# REVIEW COMMENTS

FILE #SPR-96-14

TITLE HEADING: Meineke Muffler Shop

LOCATION: 803 Ute Avenue

1 LANDSCAPING PLAN  
1" = 10'-0"

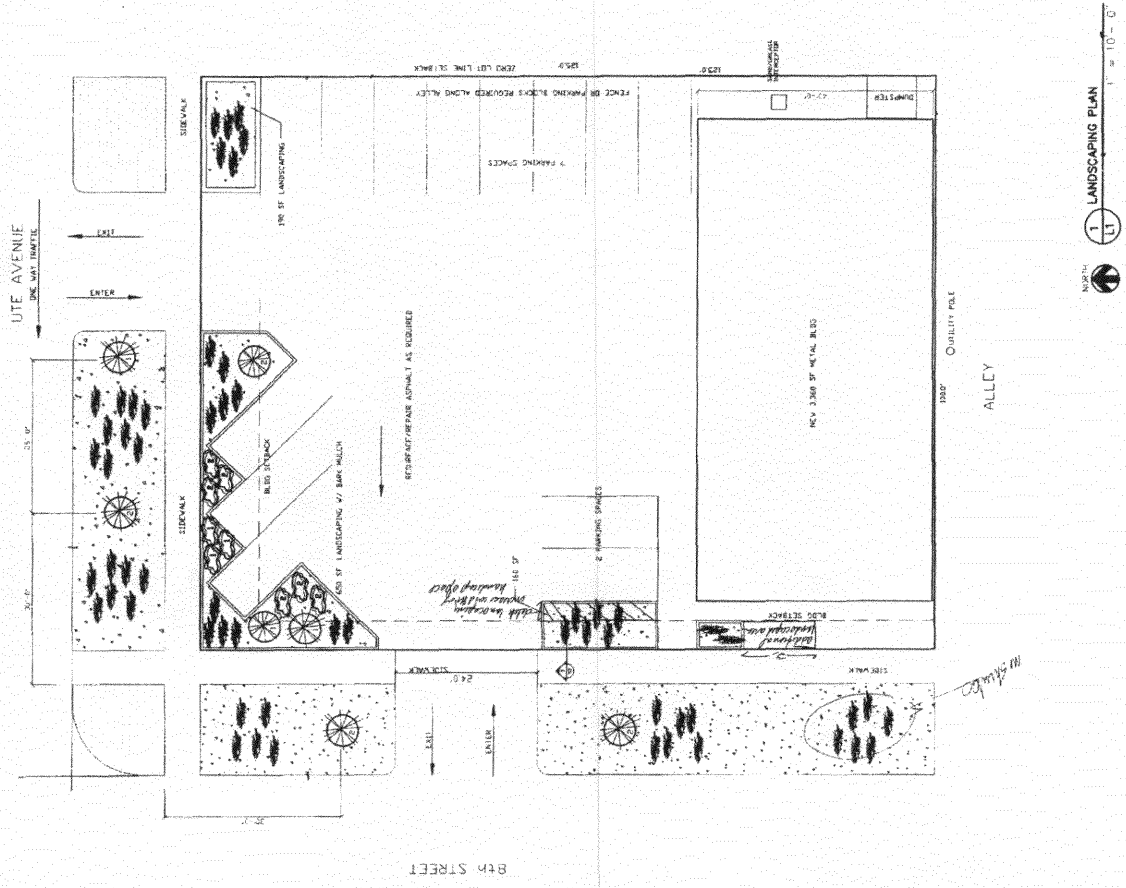
Revised Landscaping Plan

1. "Rock" areas do not count toward the landscaping requirement. The 190 s.f. area and 160 s.f. area must be landscaped and meet the 40% shrub coverage. Irrigation is required to those areas.
2. The required landscaping in the ROW must contain the street trees, as shown on the plan, and the ground cover must be in grass or meet the 40% shrub coverage. Credit cannot be given for the required landscaping for areas in rock coverage.

*Above issues addressed with revised site plan*

**1 SITE PLAN/FLOOR PLAN**  
 1" = 10'-0"

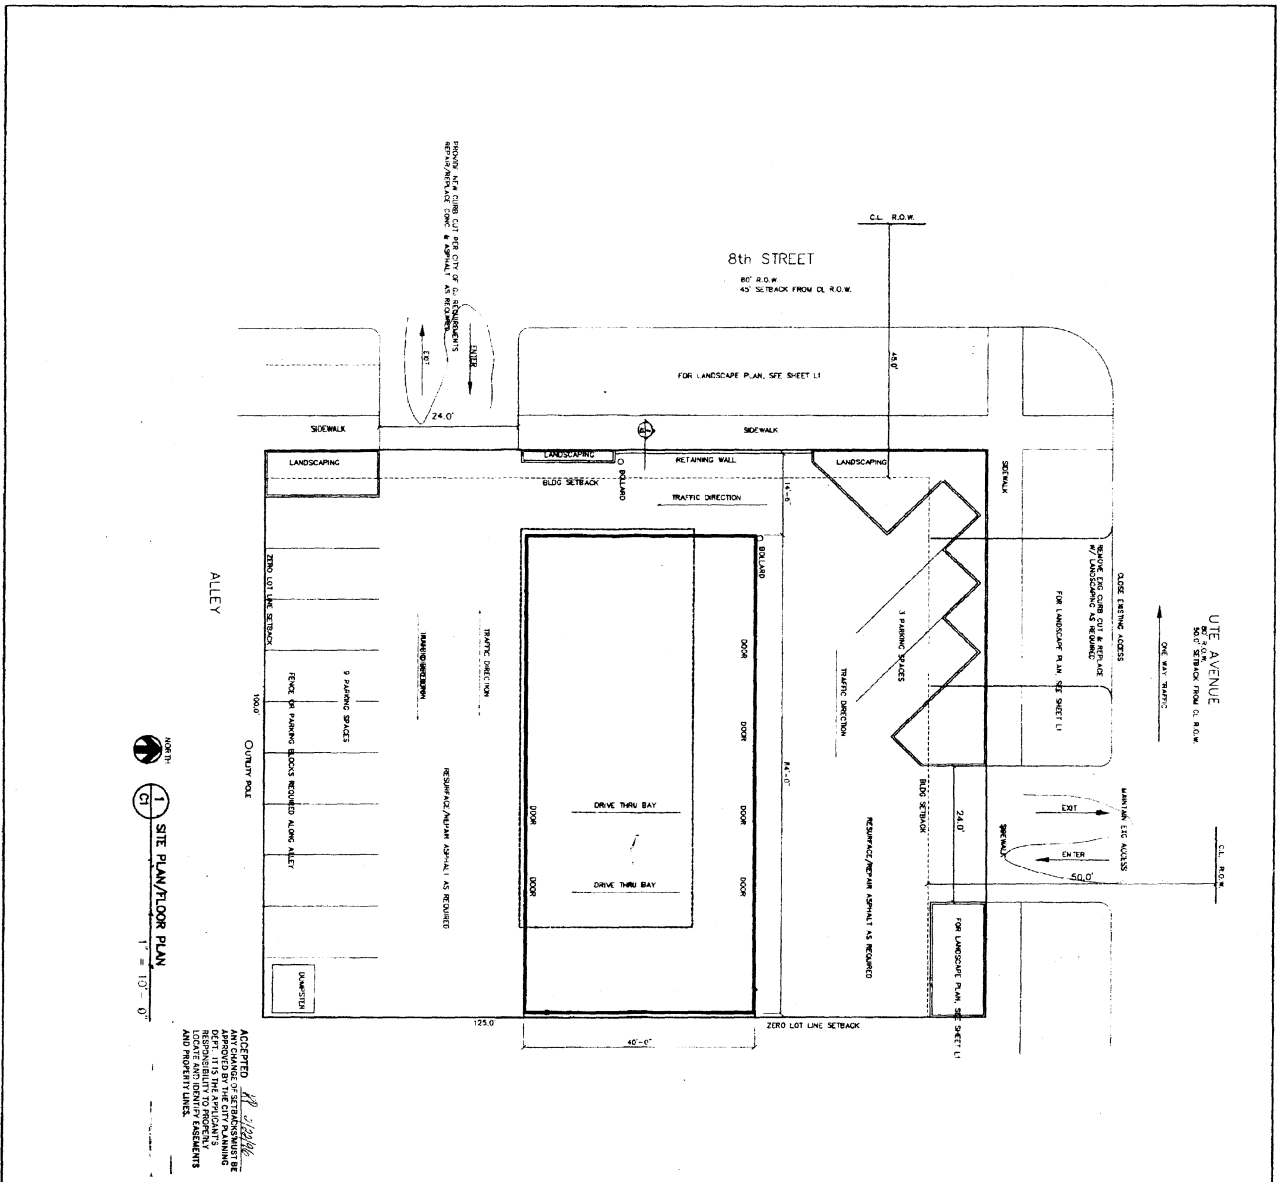
1. The parking requirement is 2 spaces per service bay plus one space per employee on the largest shift. The site plan shows 4 service bays, requiring 8 parking spaces. Please indicate the number of employees on the largest shift to confirm the required parking.
2. The required landscaping is as follows:  
Ute Avenue--100' x 10' x .75 = 750 s.f.  
8th Street--125' x 5' x .75 = 469 s.f.

The total required landscaping on the site is 1,219 s.f. The large area of ROW that must be landscaped provides a 15% credit toward the required landscaping, bringing the required on-site landscaping to 1,036. The required square footage must contain at least 3 trees and 40% of the area must be in shrub coverage.

In addition, all of the ROW between the sidewalk and curb area must be landscaped. Contact Mike Vendegna, City Forester, at 244-1549 to find out how many additional trees could be placed in the ROW and what other vegetation or ground cover he would recommend in the ROW.

The on-site landscaping shown on the plan totals 1,006 s.f. The additional square footage that is required can be waived if additional trees are provided or the trees that are provided are sized larger than the required minimum size of 1 1/2" caliper measured 1 foot above the ground level.

All landscaped areas must be served by a pressurized irrigation system.

A detailed landscape plan, as per SSID IX-20 must be submitted for review.

3. Which of the bays will have through traffic?
4. The lot should be striped with traffic circulation directions.
5. A Power of Attorney for future alley improvements is required (see attached).

1. The number of employees on the largest shift will be four(4).
2. All landscaping requirements will be met. Robert Gregg has met with Mike Vendegna to discuss his recommendations. All of the landscaped areas will be served by pressurized irrigation systems. A detailed landscape plan will be submitted for review.

3. The two(2) east bays will have through traffic.
4. The lot will be striped with traffic circulation directions.
5. We will be contacting you soon in reference to A Power of Attorney for future alley improvements.
